COUNCIL ASSESSMENT REPORT

HUNTER AND CENTRAL COAST REGIONAL PLANNING PANEL

PANEL REFERENCE & DA NUMBER	PPSHCC-312 – 16-2024-420-1
PROPOSAL	Demolition of three dwellings, vegetation removal, 3 into 2 lot Torrens title subdivision, construction of 13x multi dwelling houses
ADDRESS	Lots 130, 129 & 151 DP 31774 31, 35 & 37 Phillip Street, Raymond Terrace
APPLICANT	EPM Projects
OWNER	Homes NSW
DA LODGEMENT DATE	27/08/2024
APPLICATION TYPE	Integrated
REGIONALLY SIGNIFICANT CRITERIA	Section 2.19 (1) and Clause 5 of Schedule 6 of <i>State Environmental Planning Policy (Planning Systems) 2021</i> declares the proposal regionally significant development as the development is affordable housing with a capital investment value of more than \$5 million.
CIV	\$6,090,000 (excluding GST)
CLAUSE 4.6 REQUESTS	Yes – Clause 4.1B Minimum lot sizes for dual occupancies, multi dwelling housing and residential flat buildings
KEY SEPP/LEP	<ul style="list-style-type: none"> • State Environmental Planning Policy (Biodiversity and Conservation) 2021 • State Environmental Planning Policy (Planning Systems) 2021 • State Environmental Planning Policy (Resilience and Hazards) 2021 • State Environmental Planning

Figure 15: Hume Building A & LAHC Building A Side Setback

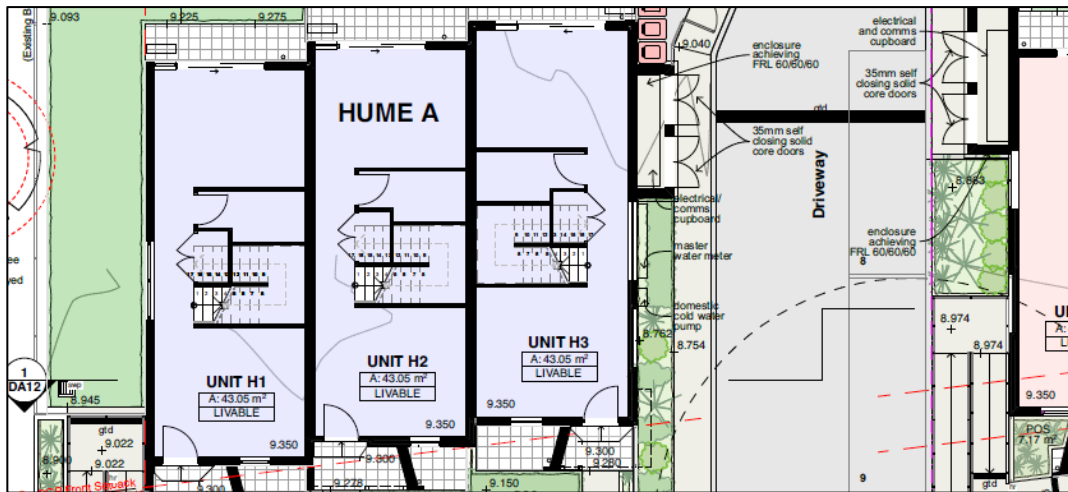
In considering the lots shape and the proposed buildings layout, the western setback from Hume Building A and LAHC Building A, and the north-eastern setback from Hume Building B and LAHC Building B are considered to be the side setbacks. A 3m ground and upper floor setback is proposed for Hume Building A & B which complies, while a setback of 2.1m and 2.35m is proposed for the upper and ground floors of LAHC Building A & B respectively, refer to **Figures 15 - 17**.

This represents a variation of 0.9m and 0.65m to the upper floor setback requirement, with the ground floor setback complying. The variation is recommended to be supported for LAHC Building A, noting the western side boundary adjoins the proposed driveway and therefore would have no material impact on any adjoining properties or the streetscape character. The variation is also recommended to be supported for LAHC Building B as it enables increased solar access into the private open space to the south, provision of a bin storage area behind the building line and would not result in any adverse privacy or overshadowing impacts to the adjoining lot to the north.

Figure 18: Hume Building B Rear Setback

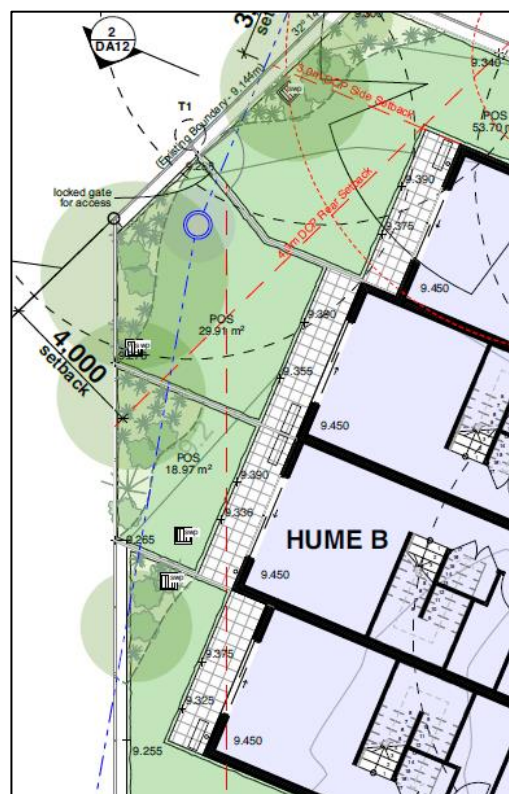
Based upon the buildings configurations, the northern setback for Hume Building A and LAHC Building A and the north-western setback of Hume Building B and LAHC Building B are considered to be the rear setback. Hume Building A features a ground and upper floor rear setback of approximately 25m which complies and LAHC Building A features a ground and upper floor rear setback of approximately 12.3m which complies. Hume Building B features a rear setback that varies from 2.4m to 6m, representing a maximum variation of 1.4m and LAHC Building B has a rear ground and upper floor setback of 0.3m from the new proposed boundary line, refer to **Figures 18 & 19**.

The variation for Hume Building B has is recommended to be supported on merit, noting it is primarily due to the lots irregular shape, with the majority of the building complying with the setback requirement. As such, there would be no significant adverse impacts as a result of the variation. Similarly, the setback variation for LAHC Building B adjoins the new proposed lot boundary and car parking area. As such, there is approximately 14m of separation between any other dwellings and the elevation does not overlook any private open space. As such, there would be no adverse impacts as a result of the variation and is recommended to be supported on merit.

Figure 21: Partial site plan showing planters and bus seat

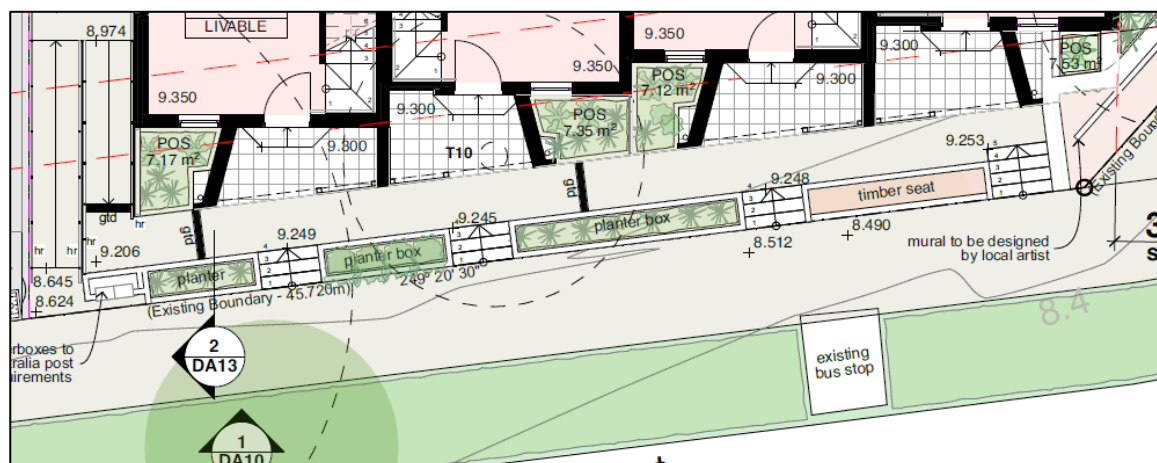
residents and also the broader community who utilise the bus stop, refer to **Figure 21**. Additional landscaping outcomes are achieved by the planting of street trees along the Phillip Street road verge, providing canopy coverage to help soften hardstand areas.

In considering the accessibility outcomes as a result of the hardstand areas and the implementation of high quality landscaped outcomes, the hardstand encroachment is considered to be acceptable and the proposed development is considered to have an overall positive outcome on the streetscape presentation of the locality.

Figure 22: Partial site plan showing initial waste storage and Unit L4 private open space

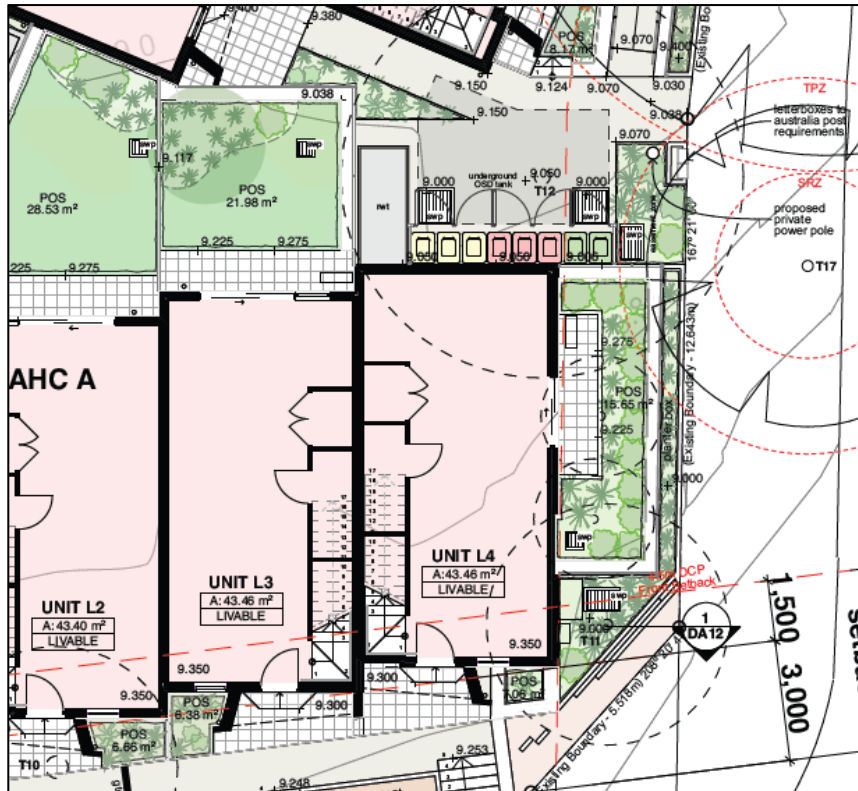
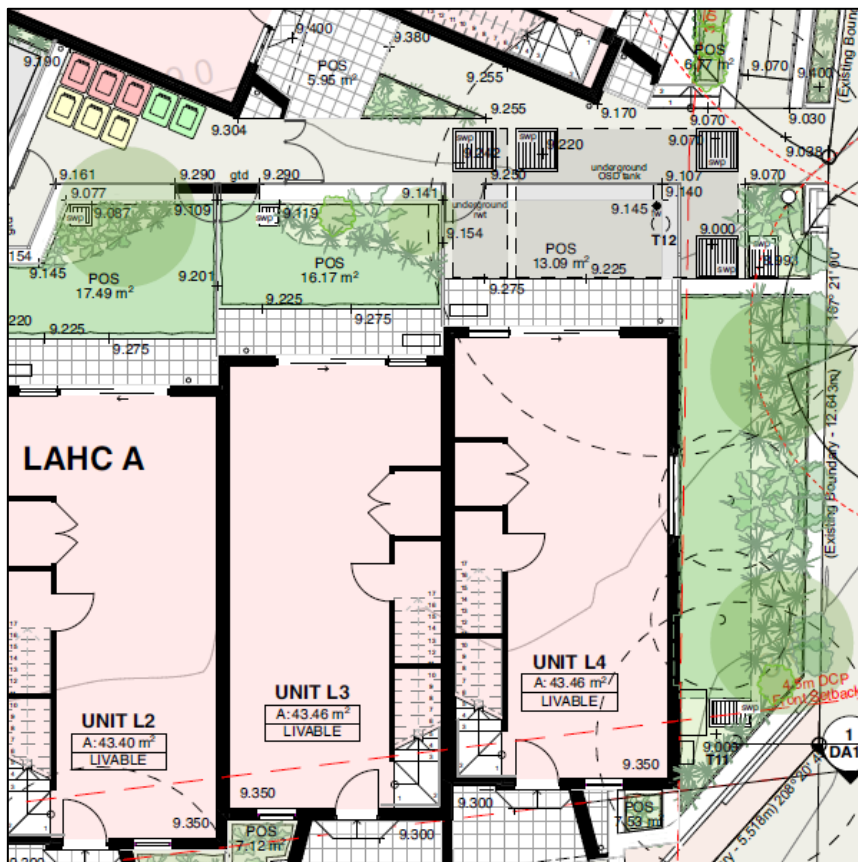
Several concerns were raised regarding some of the dwellings private open space, including solar access, interaction with waste storage areas and fencing and security for future residents. Council initially noted that the private open space for Units L2-L6 and H2 were heavily impacted by shadows. Furthermore, during the preliminary briefing with the HCCRPP, it was noted that the northern elevation of Unit L4 was compromised by the bin storage area and its private open space was located forward of the front setback, reducing privacy and security for future residents.

In response, the applicant provided amended plans to address the concerns raised. Firstly, the proposed buildings massing and setbacks were altered slightly, allowing for increased solar access to the living areas of the dwellings and their private open space. The waste storage area for the social housing dwellings was also relocated to a screened location to provide a north facing hardstand courtyard for Unit L4, refer to **Figures 22 & 23**. This also allowed for additional landscaped area on the eastern façade to Windsor Street to provide additional privacy for the residents. Extended screening was also provided for the dwellings along Phillip Street to provide greater privacy and security. Overall, the design amendments are considered to sufficiently address the concerns raised.

Figure 23: Reconfigured waste storage and private open space for Unit L4
